Addendum Number One

Date of Issue: 05/23/14

Project: USC Gambrell Refit 4th Floor Office into Classroom
Project Number: CP00393371/FM00452461

**GAMBRELL HALL
REFIT 4TH FLOOR OFFICE INTO CLASSROOM**

FOURTH FLOOR PLAN - ELECTRICAL

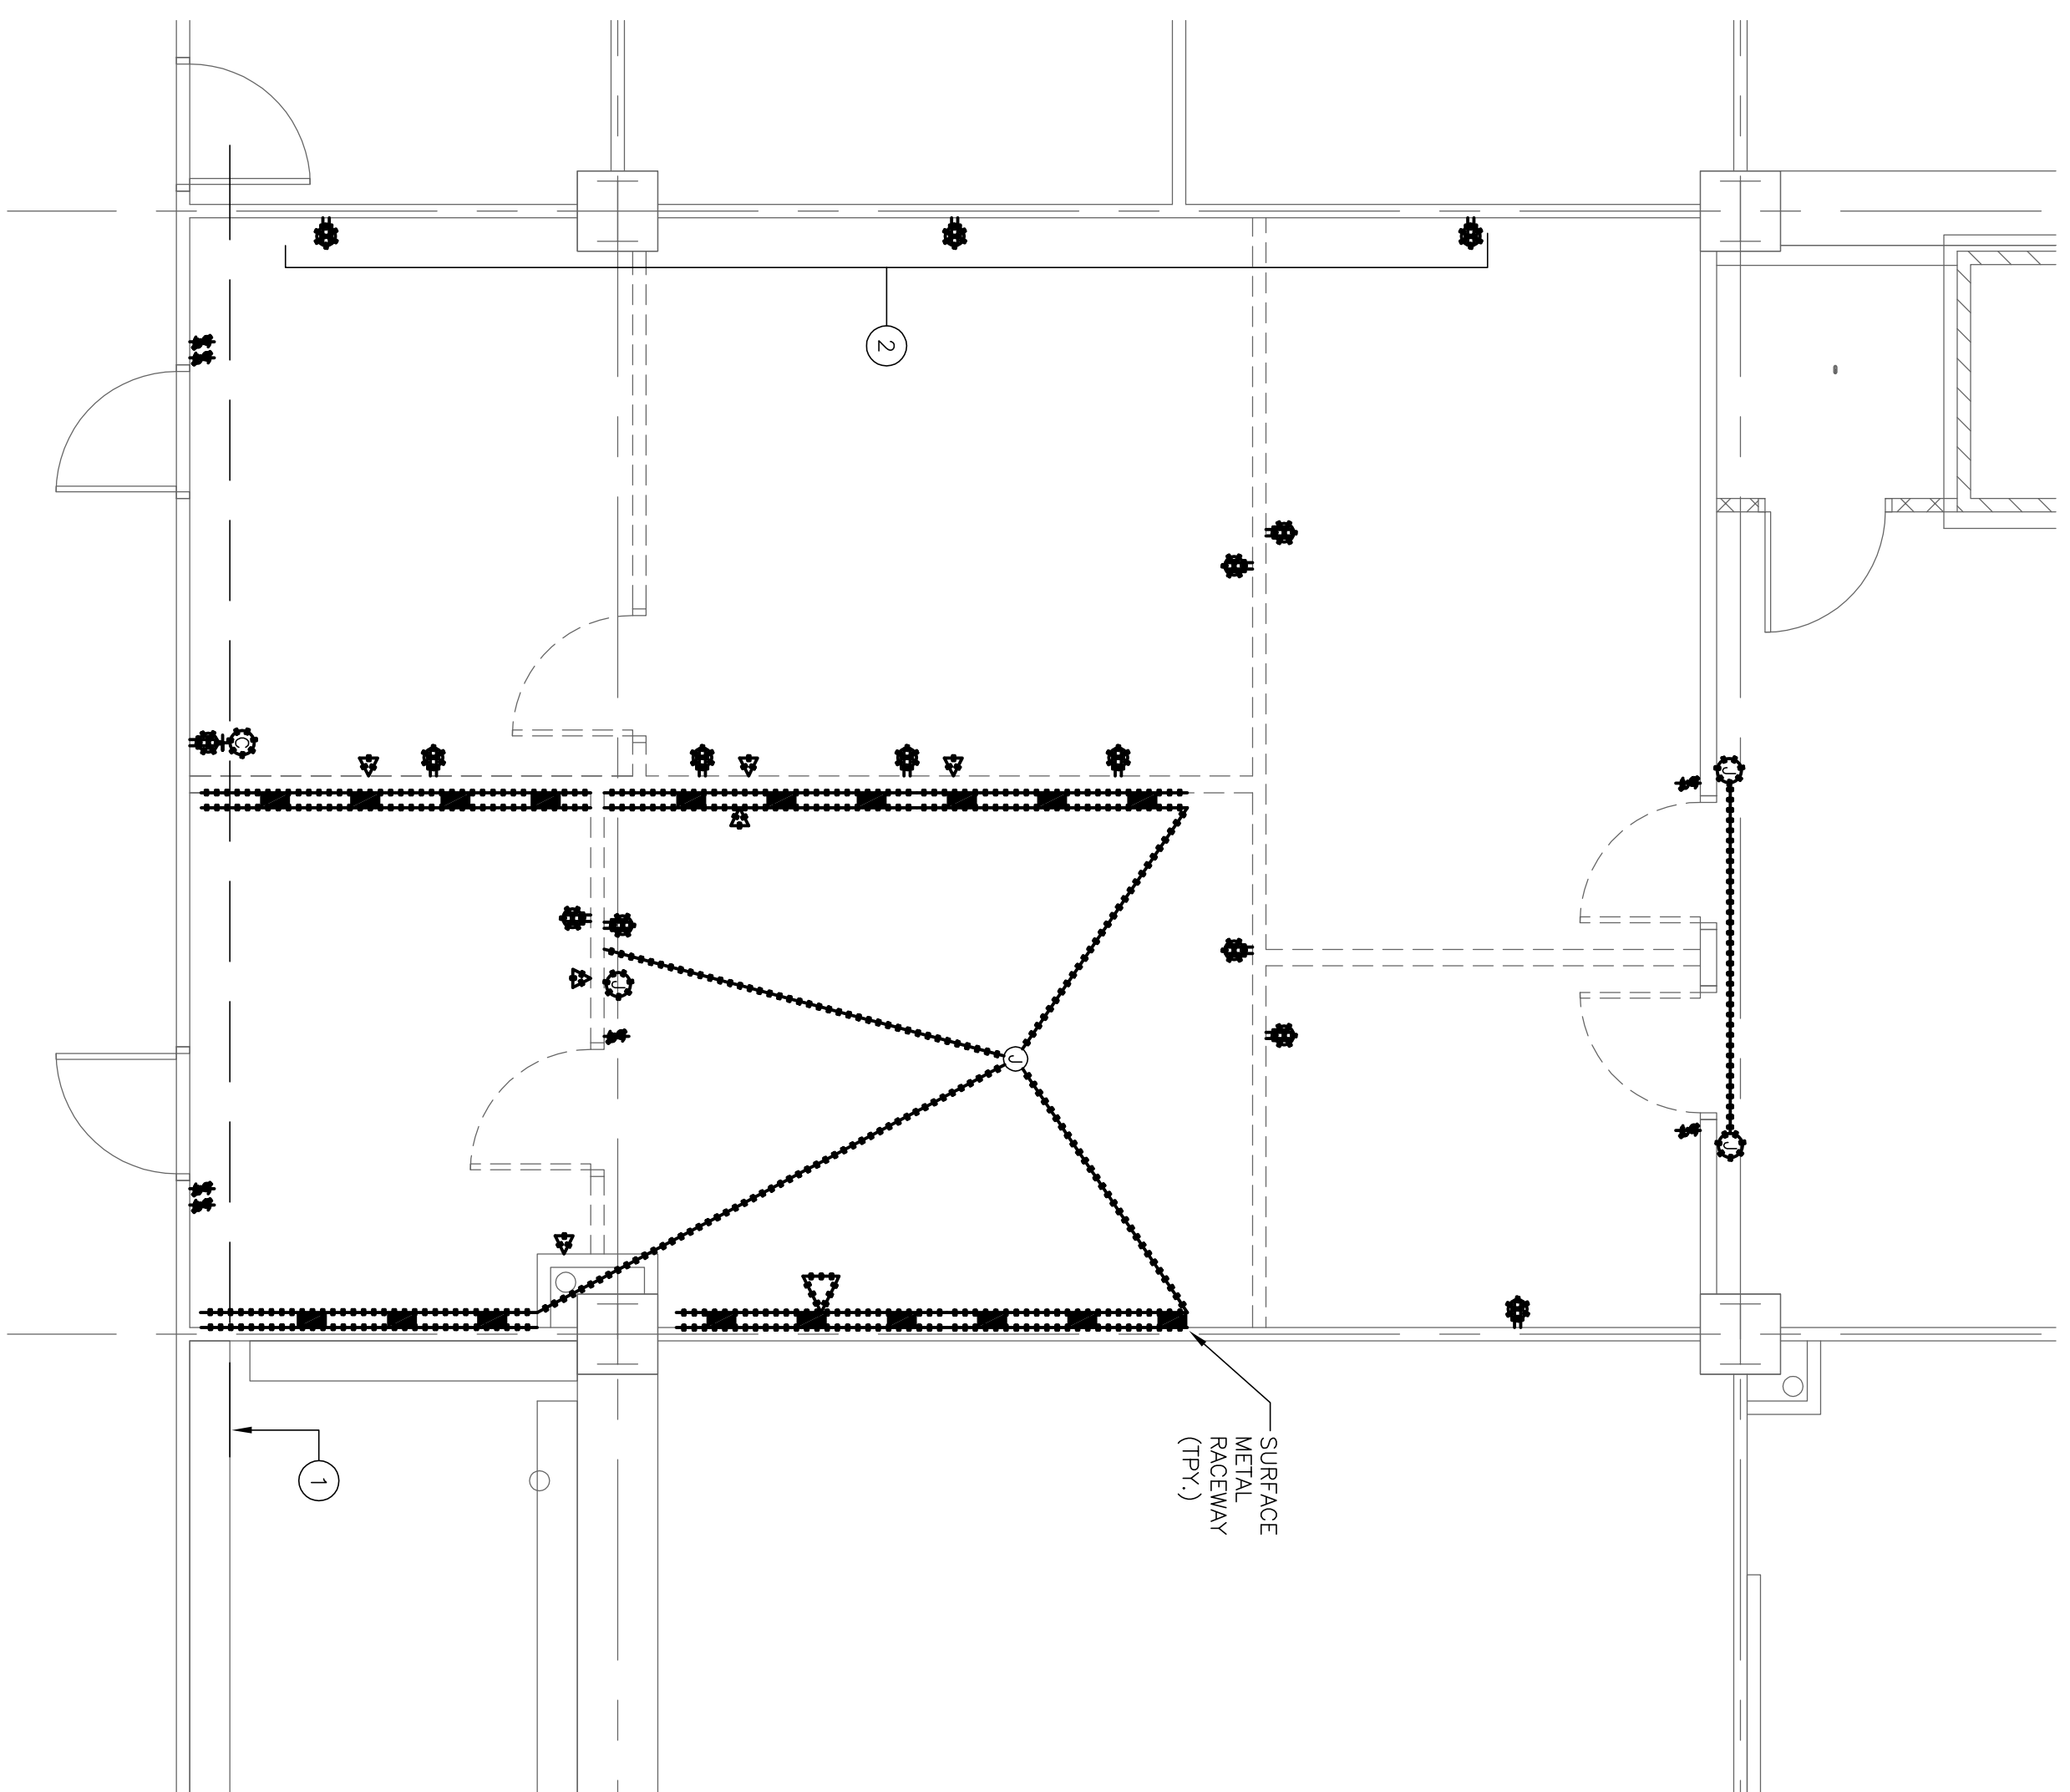
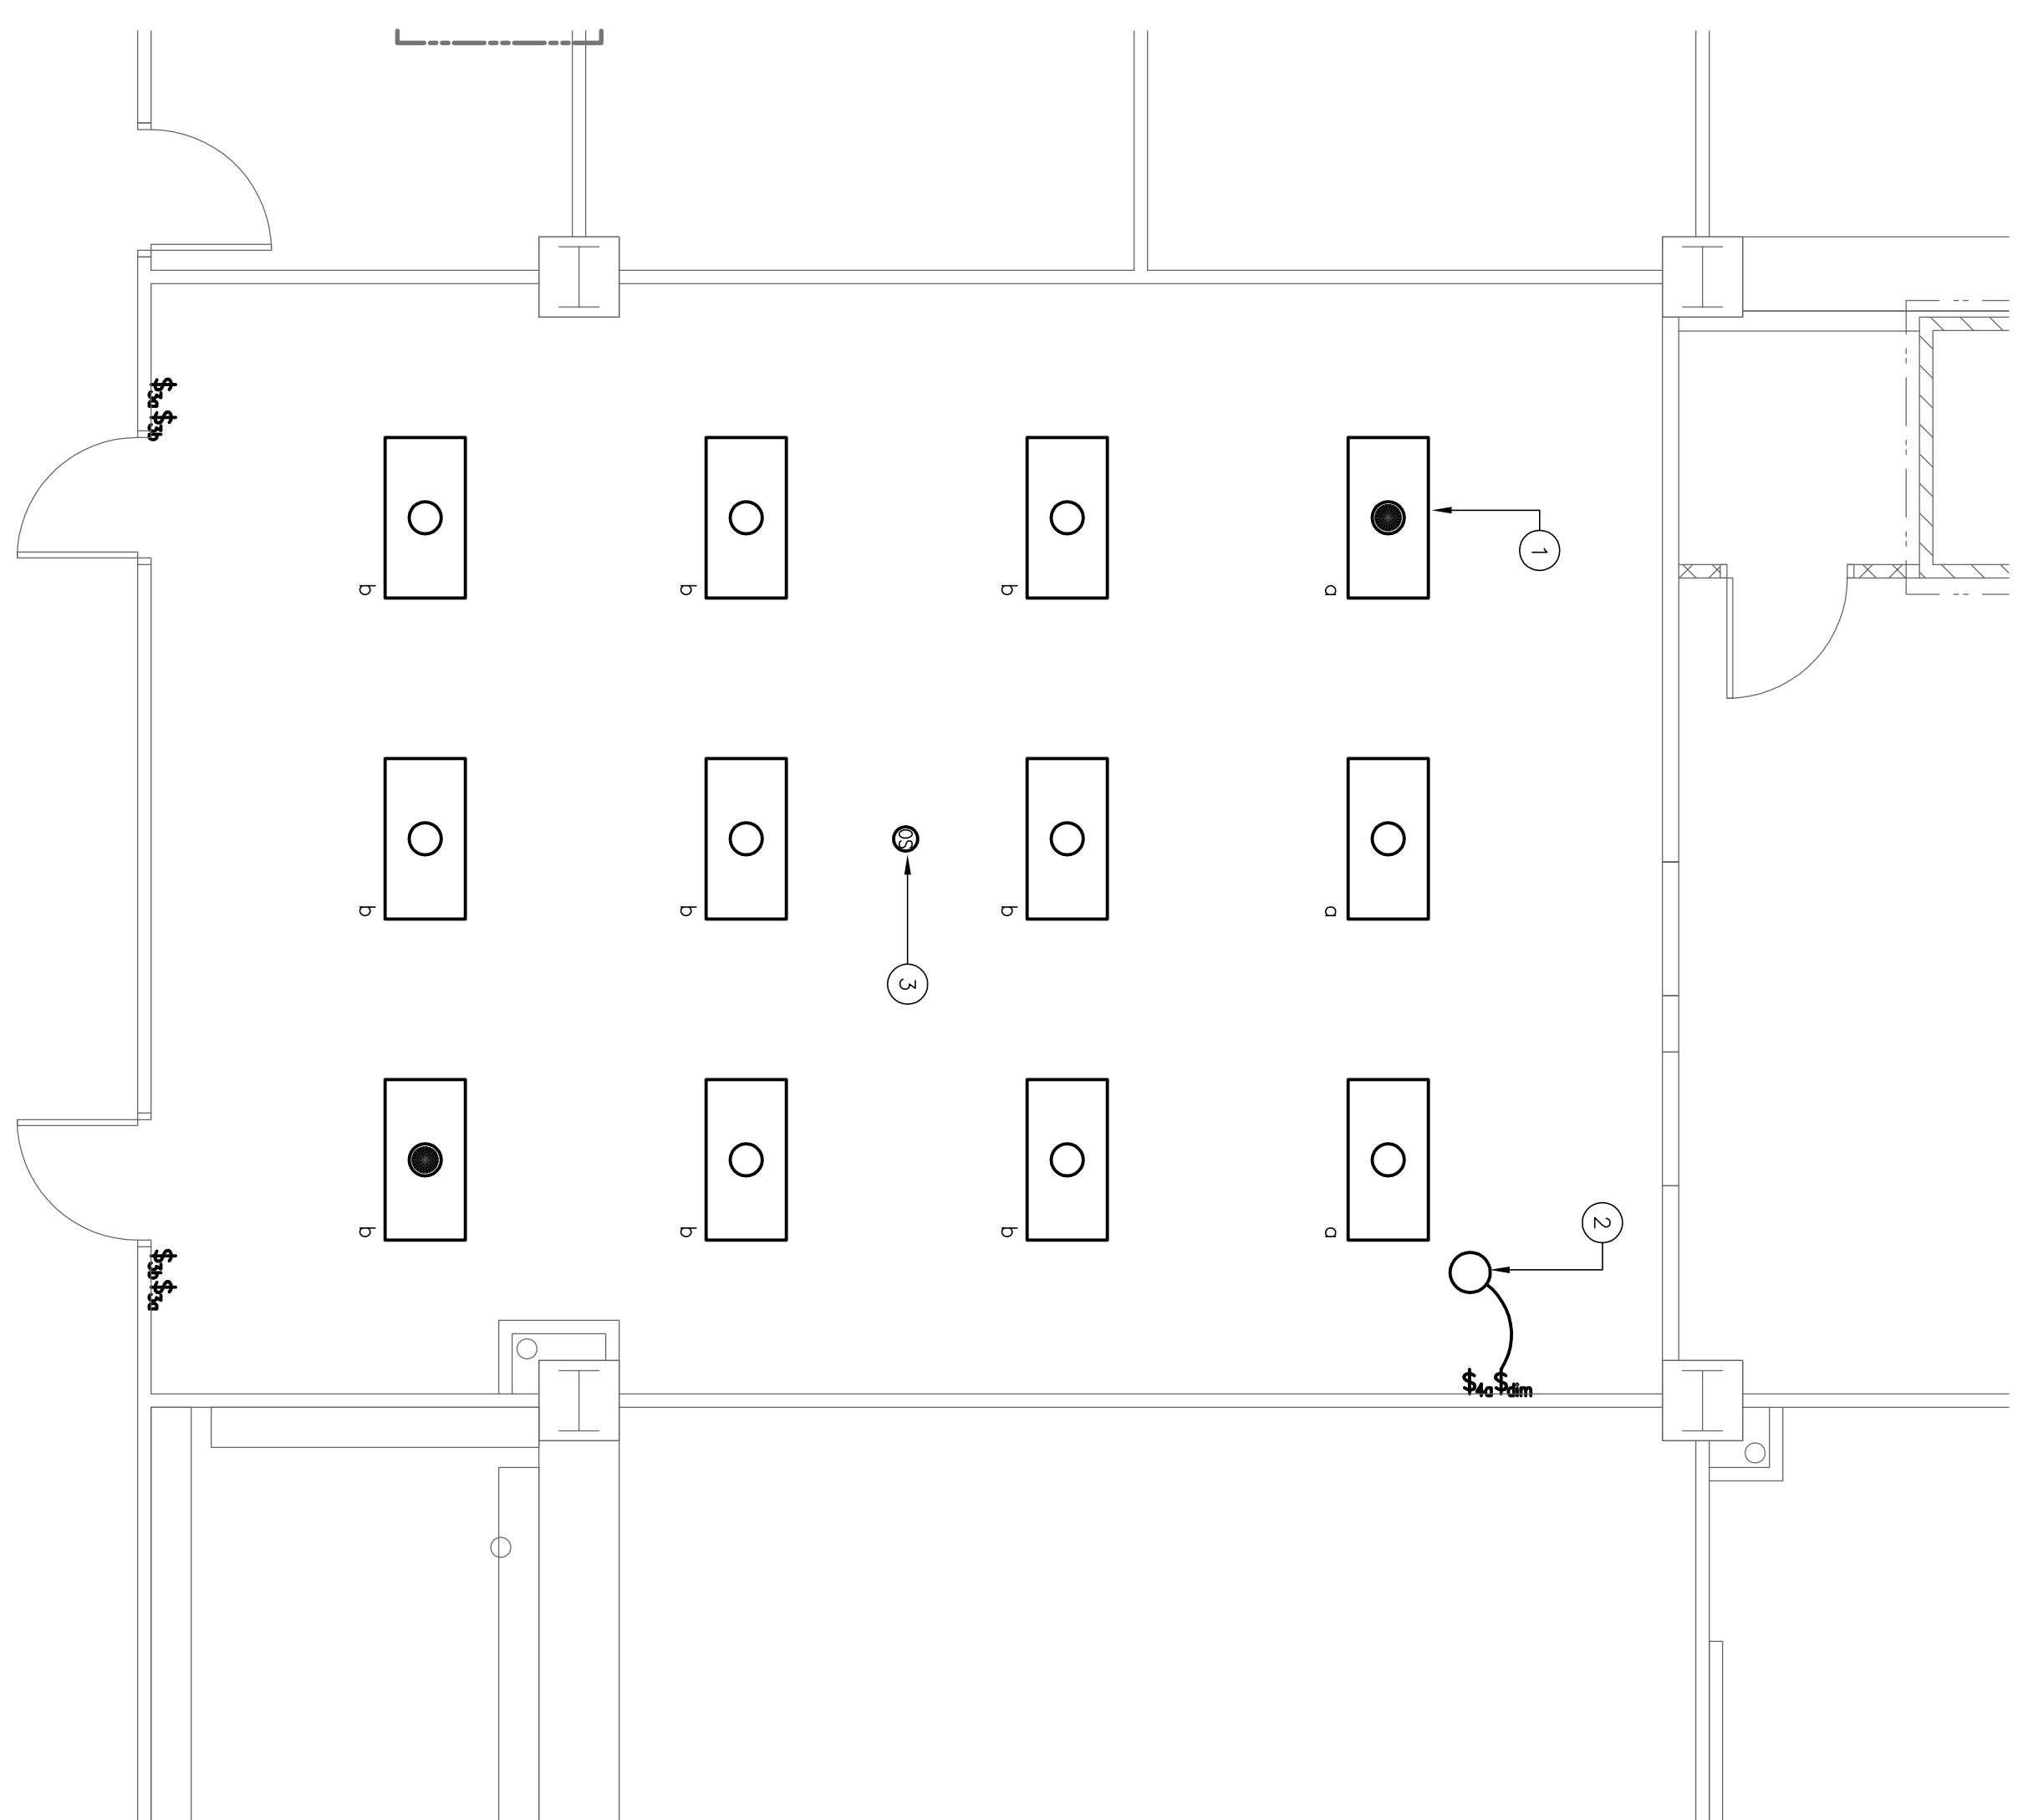
1. **SHEET A101 / Ceiling Renovation Notes** Delete Note H.
2. **SHEET E1.01 Fourth Floor Plan Electrical** Replace Sheet E1.01 with the attached sheet E1.01 dated 5/22/14. Revise the requirements for Audio/Visual rough-ins as shown.

- ① PROVIDE 1" CONDUIT FOR A/V CONNECTIONS PROVIDE TWO GANG DEEP CABLING PROVIDED BY UT, TO ABOVE CEILING FOR ROUGH-IN ONLY.
- ② PROVIDE POWER AND A/V FOR CEILING MOUNTED PROJECTOR. PROVIDE CEILING MOUNTED TWO-GANG DEVICE BOX AND QUAD-DUPLEX RECEPTACLE AS REQUIRED.
- ③ CONNECT RECEPTACLE TO NEAREST 20 AMP CIRCUIT. EXTEND REMAINING CIRCUIT AS REQUIRED.
- ④ PROVIDE RECEPTACLE AND COVER PLATE. CONNECT TO EXISTING BRANCH CIRCUIT WIRING.
